Landscape Architecture

AM Blocks Narrative regarding fourteen (14) drawings attached being modified with date 9-22-2020. These sheets are being modified to allow curvilinear Abernethy landward bonus plazas with expanded lawn that flows up to meet bonus plazas providing more welcoming spaces from the trails that are easily accessed by pedestrians. Reference drawing C.216 Subarea 3 that indicates that 80% of Subarea 3 is still being provided as required, that 60% of required landscape is planted in shrubs, and revised tabulation is provided for ground cover. These calculations are over minimum required. Exhibit C.219 indicates that to provide shrubs over required, some ground cover was reduced and some shrubs were increased. These two (2) above mentioned drawings can be compared to same drawings dated 6-22-2020. Drawing C.218 indicates that trees remain unchanged – this drawing has been re-submitted as Bonus area and maker's plaza have changed.

GREENWAY REVIEW # (LU-20-102914 DZM GW) EXHIBIT C.215

LANDSCAPE - GREENWAY LIGHTING / DEVELOPMENT PLAN- OVERALL

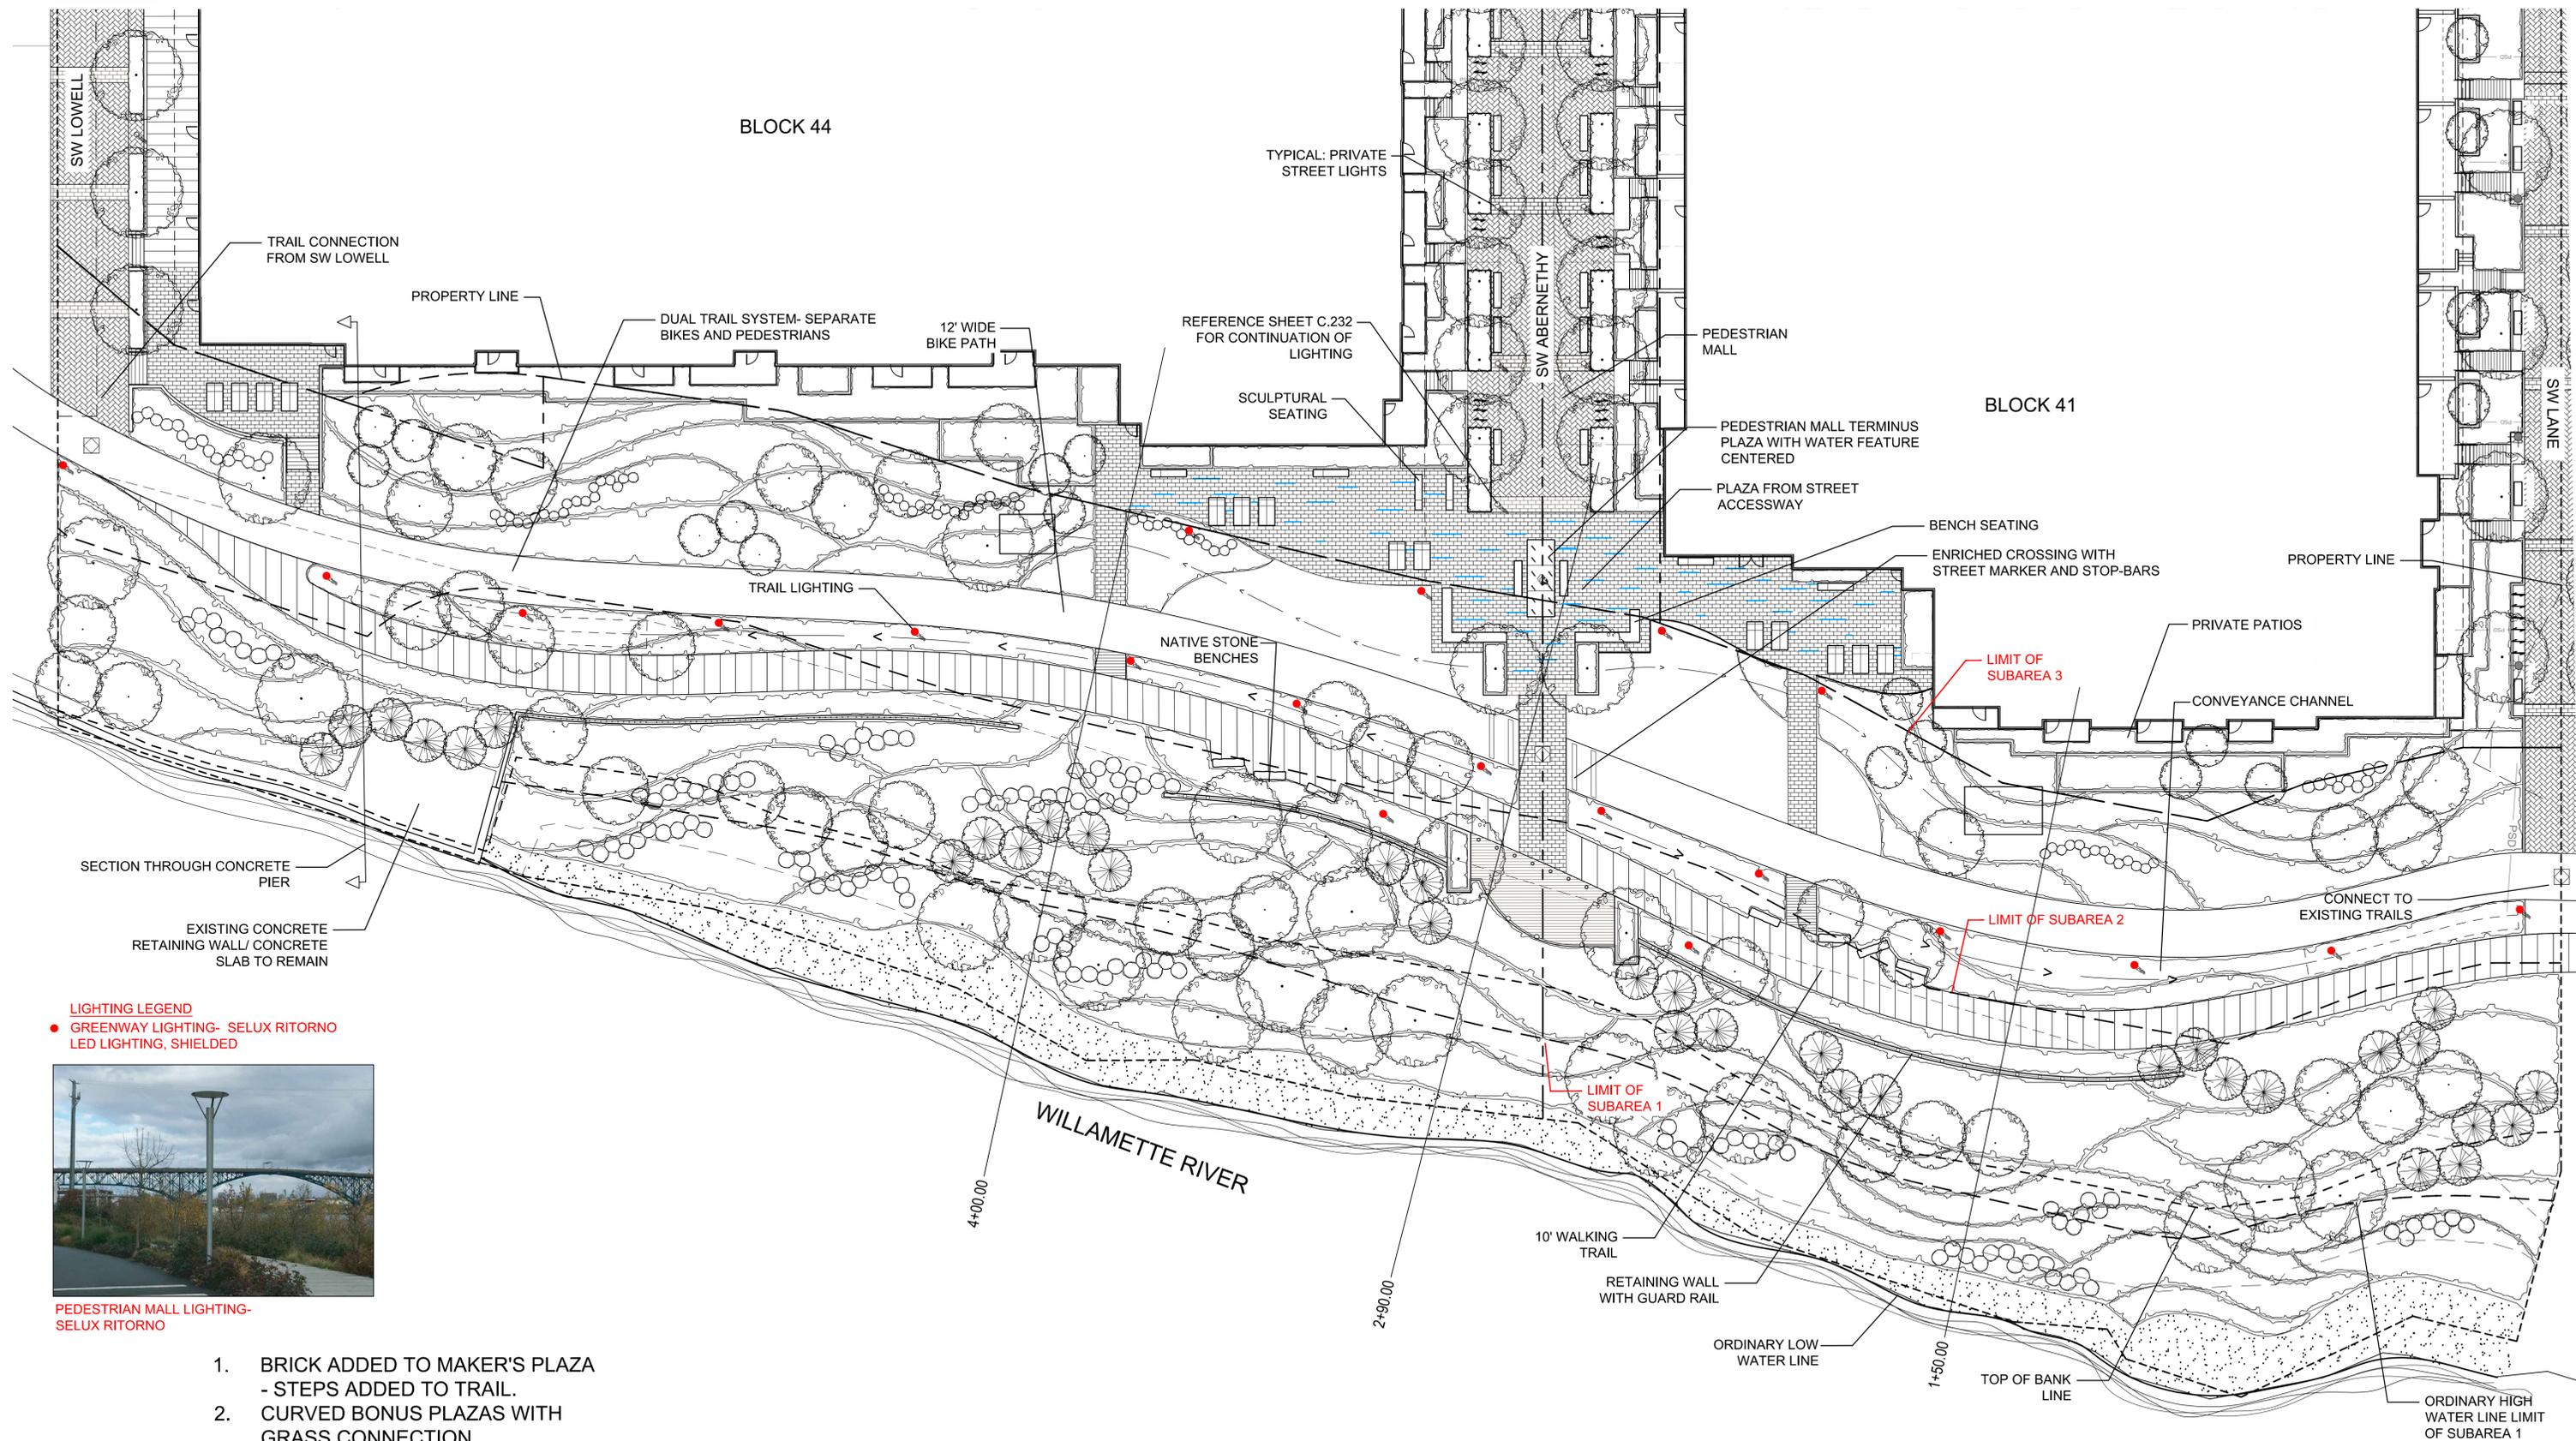
1. BRICK ADDED TO MAKER'S PLAZA - STEPS ADDED TO TRAIL.
2. CURVED BONUS PLAZAS WITH GRASS CONNECTION
3. LIGHTS LOCATIONS AT BONUS PLAZAS MODIFIED

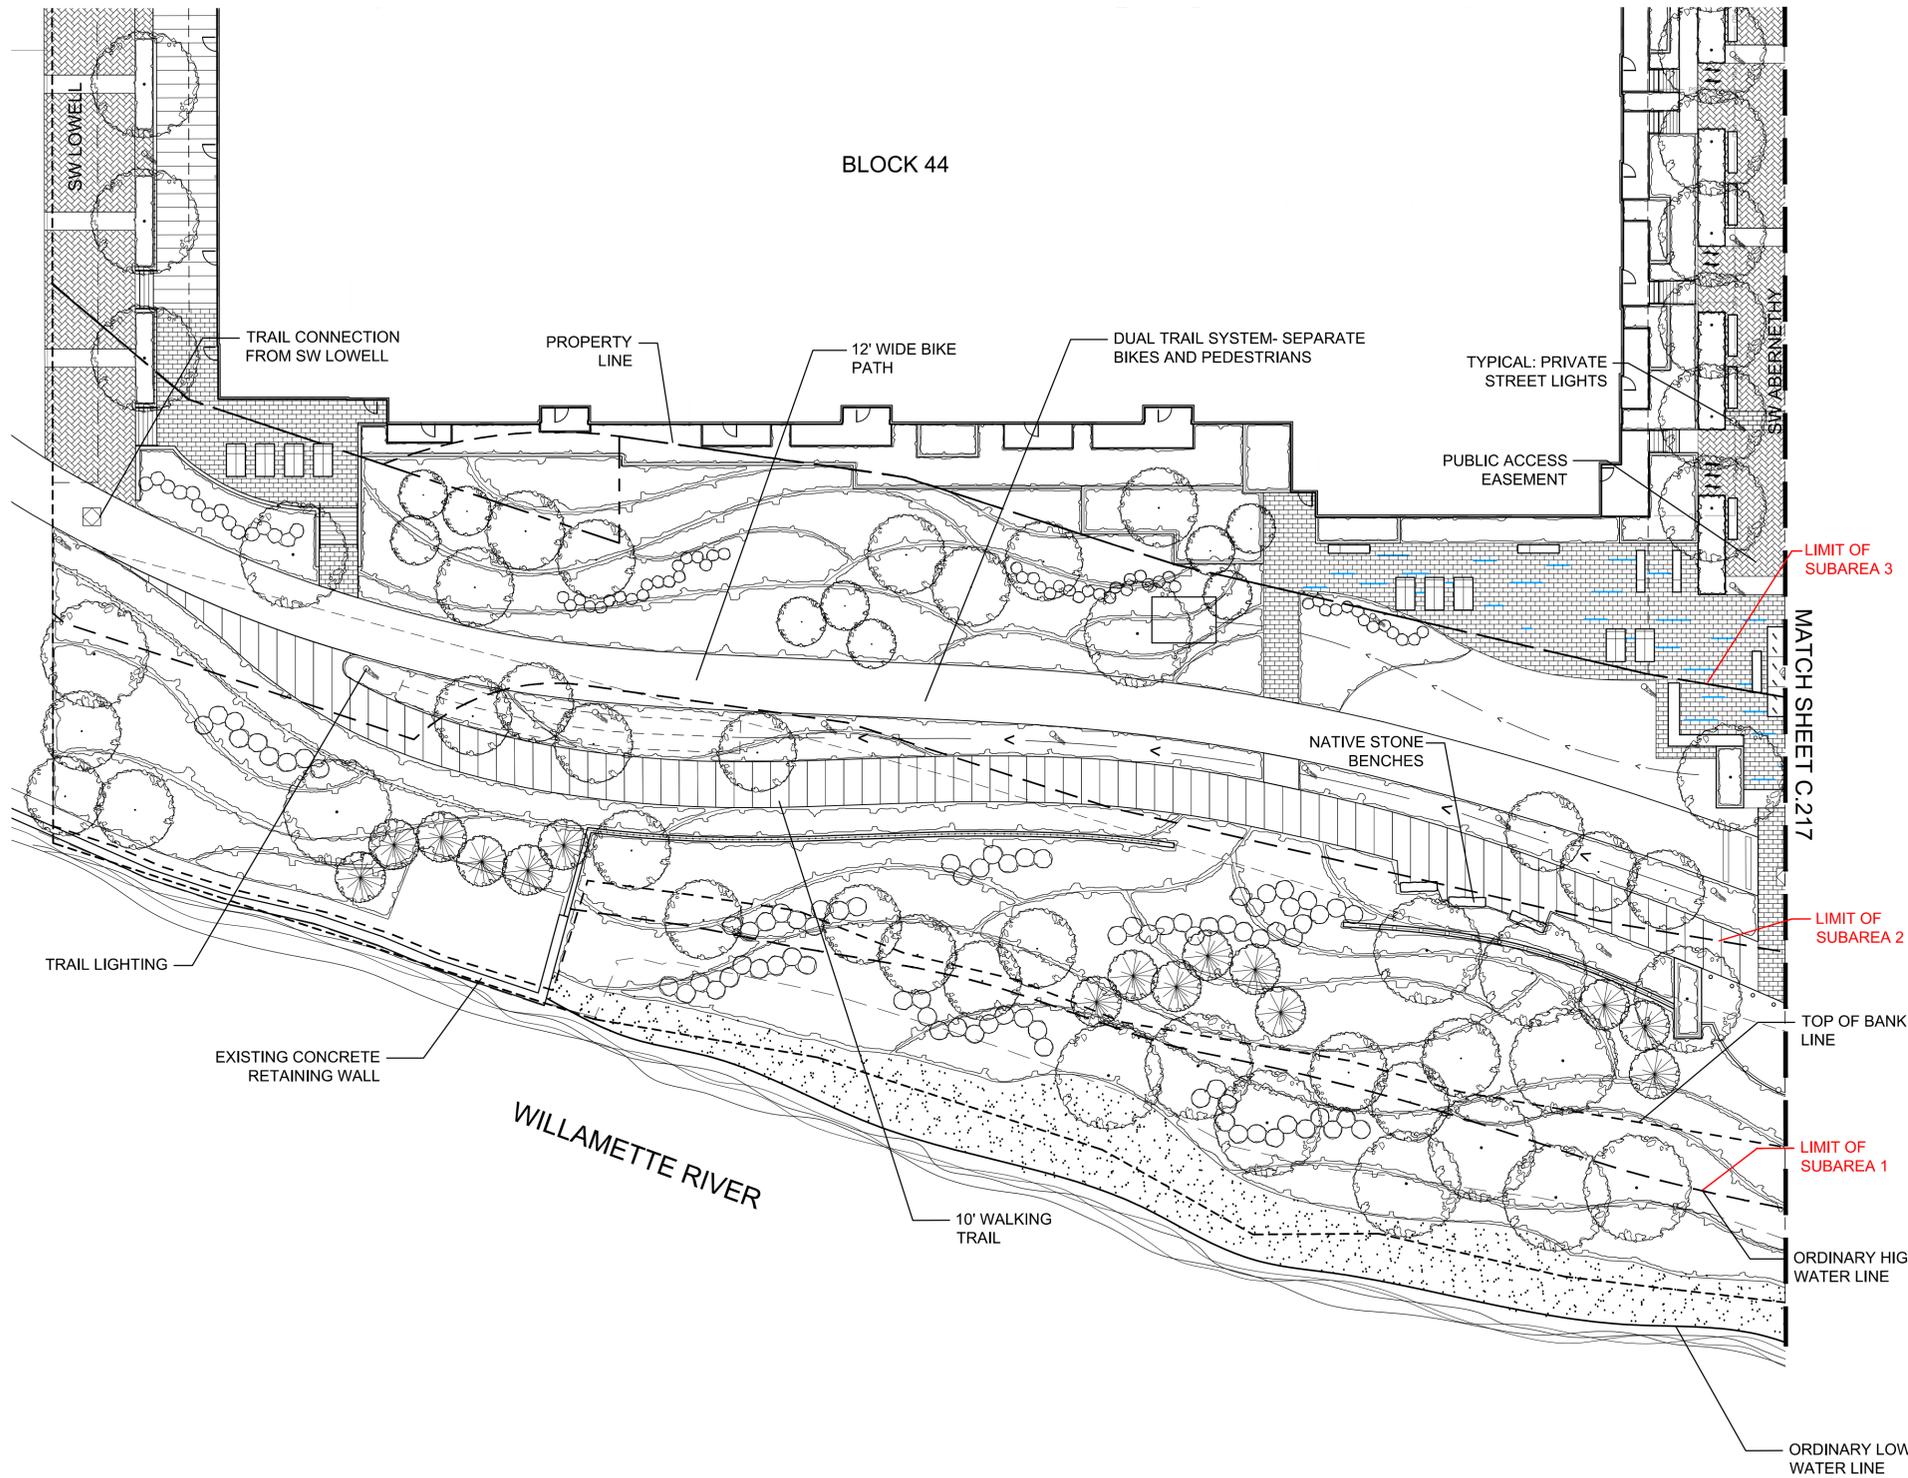
1. BRICK ADDED TO MAKER'S PLAZA - STEPS ADDED TO TRAIL.
2. CURVED BONUS PLAZAS WITH GRASS CONNECTION
3. CHART MODIFIED

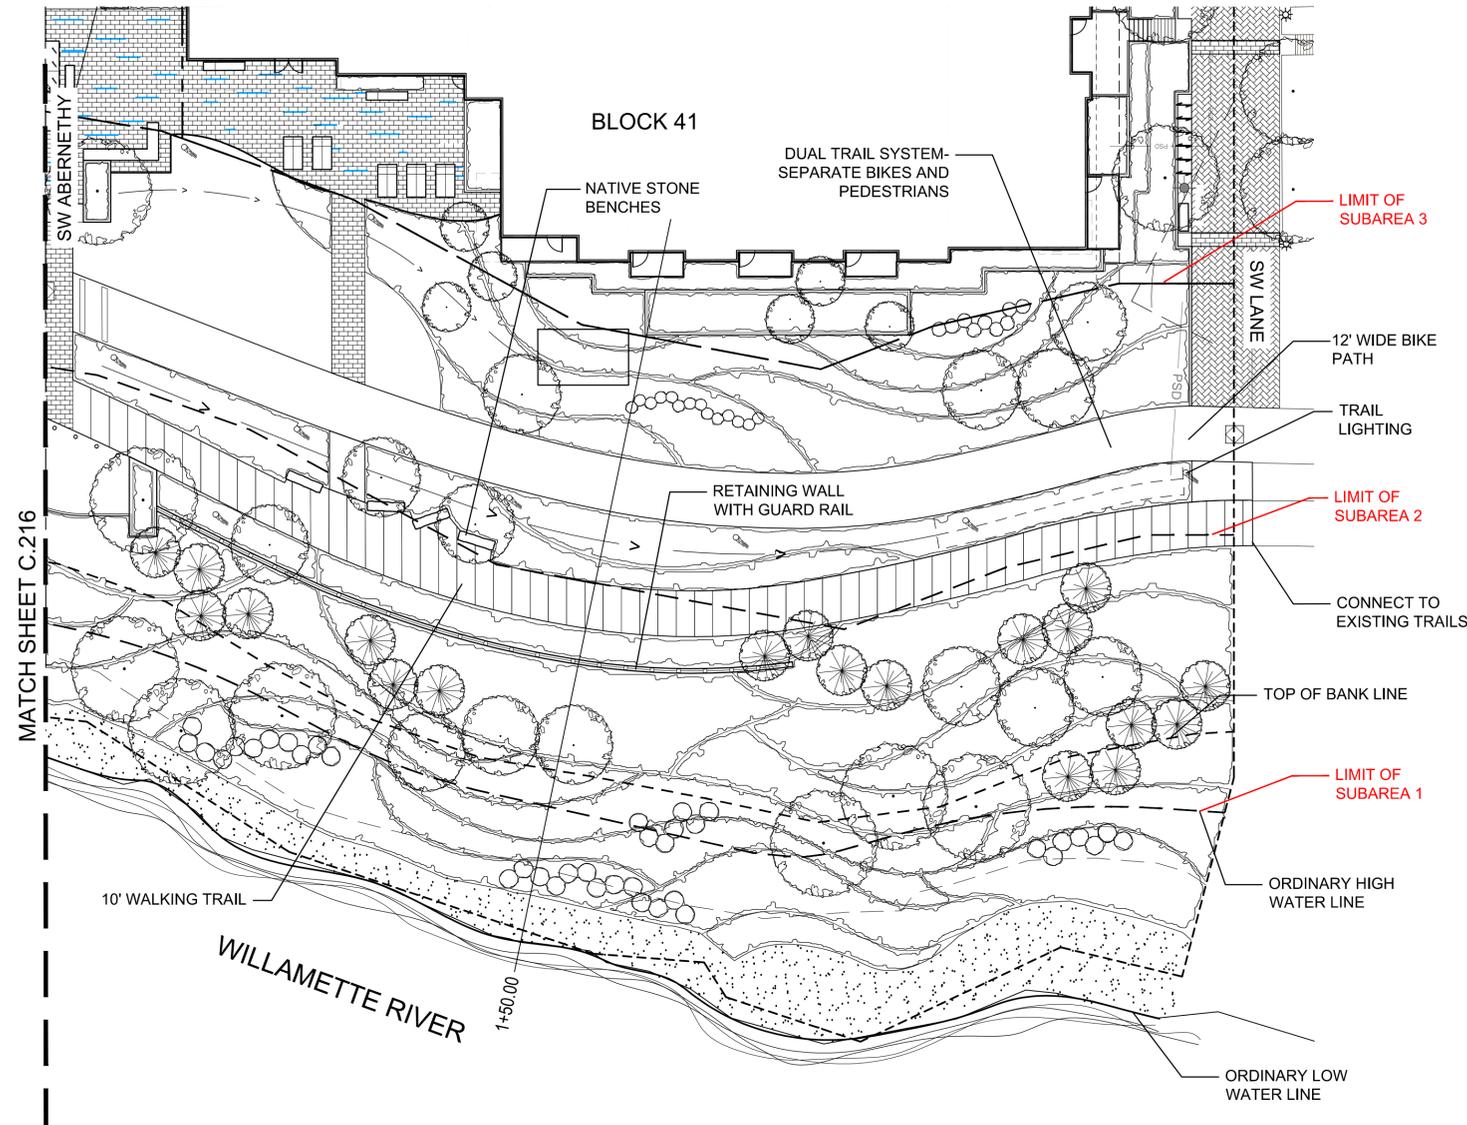
1. CURVED BONUS PLAZAS WITH GRASS CONNECTION

GREENWAY/ SUB-AREAS 1, 2, & 3 PLANT LIST IMAGES

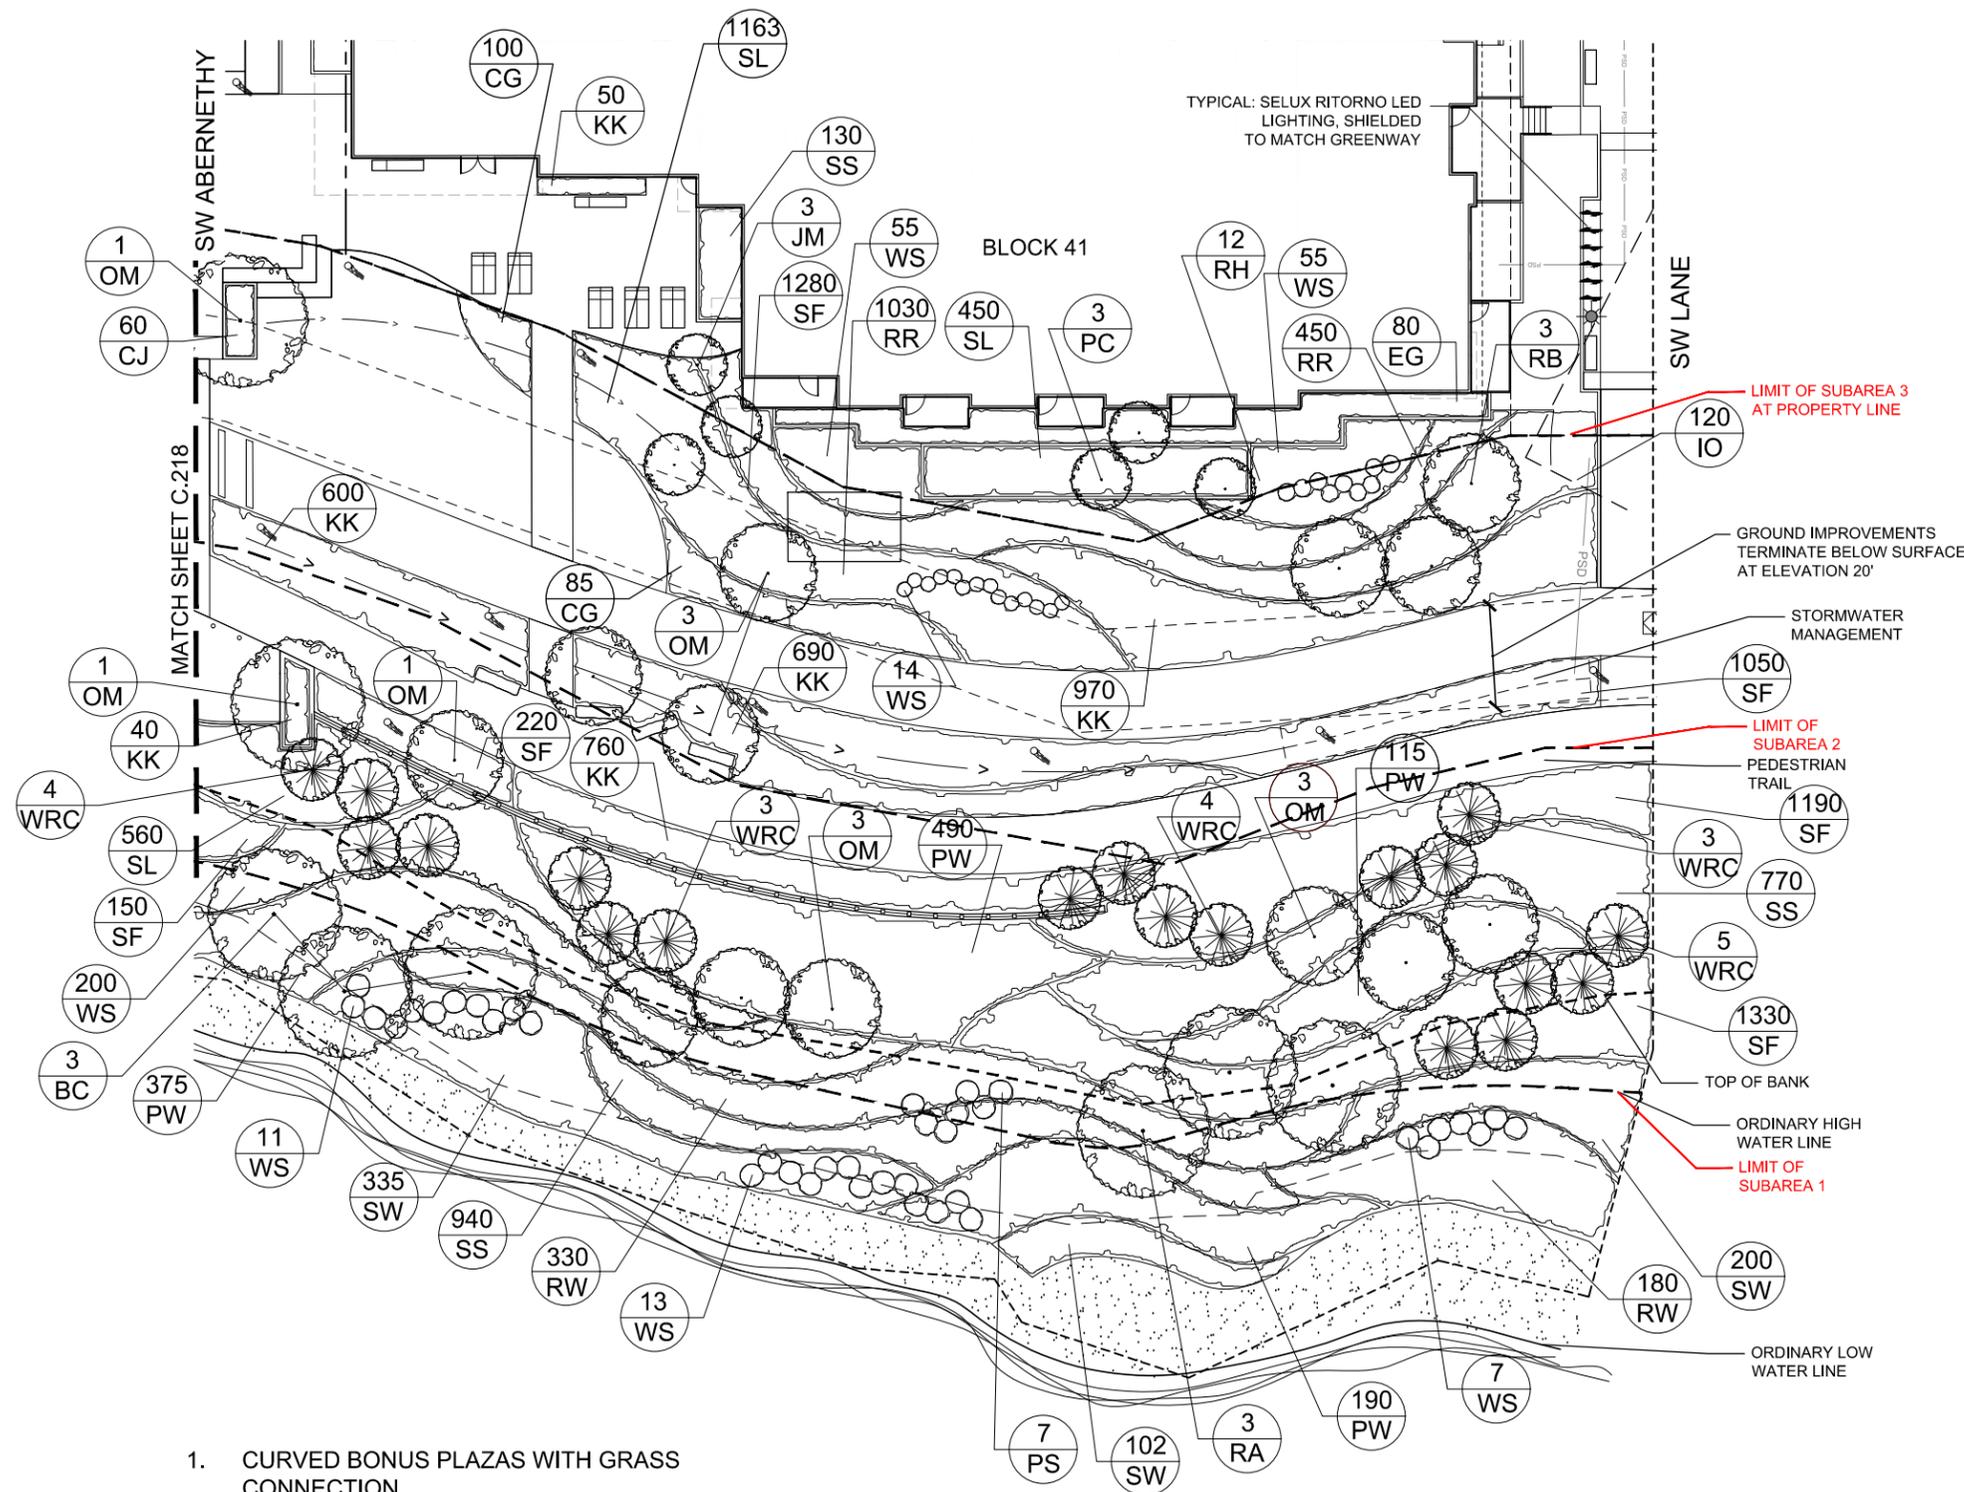
1. CURVED BONUS PLAZAS WITH GRASS CONNECTION
2. PLANTING MODIFIED
3. SUB AREA 3 PLANTING CHART UPDATED
